ADDENDUM NUMBER 04

**PROJECT: LAUDERDALE COUNTY INNOVATION CENTER
GMC PROJECT NO. ABHM210017**

ADDENDUM #04

Bernhard TME Project No. 12-22-0082
Client Project No. ABHM210017

4 RISER 40 - STOR 172 HD/LIFE ACADEMY 171 SK
SCALE:

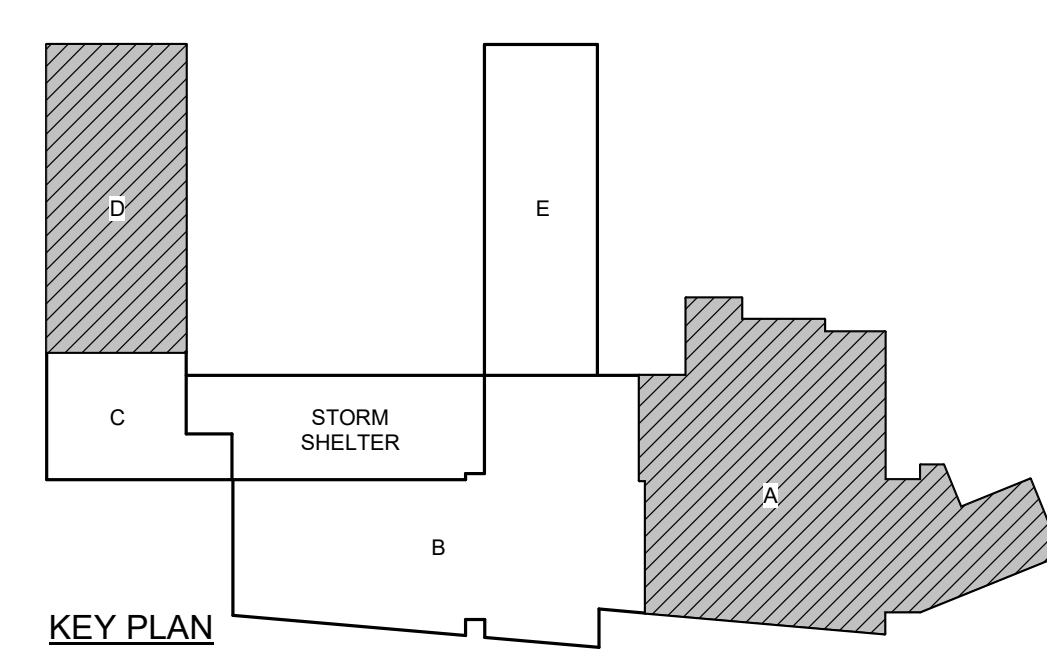
9. Refer to Revised Sheet (P3.04) – (RISERS – SANITARY CONT.) – revision dated (2023-11-03):
 - A. **REVISE** Riser 40.
